**ADDENDUM NUMBER ONE**  
**RFQ # 7549014**

**TITLE: Electrical Upgrades to Cosmetology Shop Area at Davies School**

Item #6  
 Collins SOCC-WALL STATION  
 Single wall station

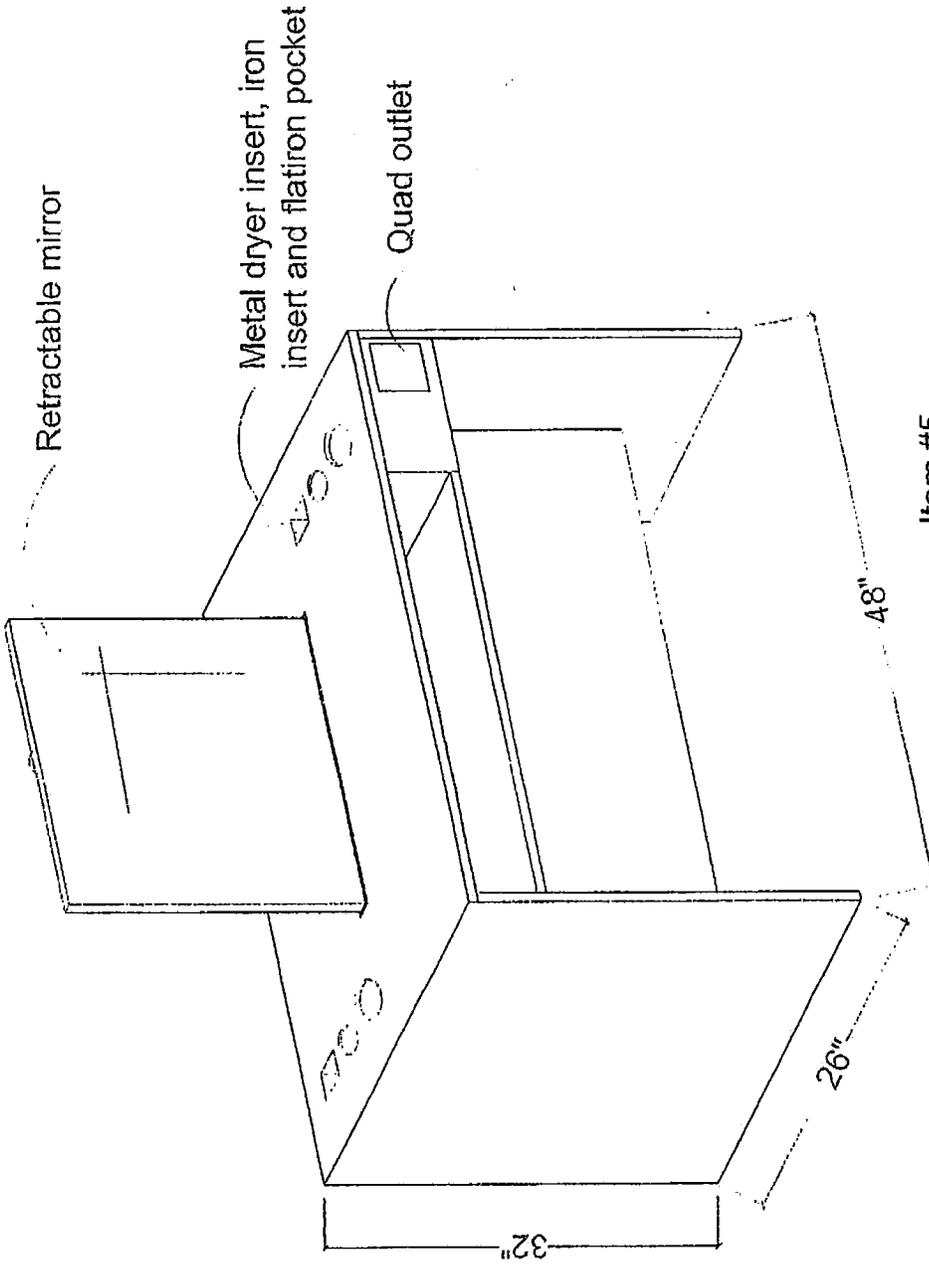
1. The workstations to be furnished by the owner have a quad outlet built into the furniture. Refer to the attached catalog cut sheets (Collins SOCC-BACK TO BACK station, and Collins SOCC-WALL STATION single wall station). The quad outlets in these units are to be wired in the field by the contractor using EMT conduit and wire. No wiring is furnished by the manufacturer. Install conduit/wire below the top surface of the unit, concealed as much as possible. Split the quad outlets to allow two circuits for each quad. The dog house style receptacles indicated on the plans will not be required.
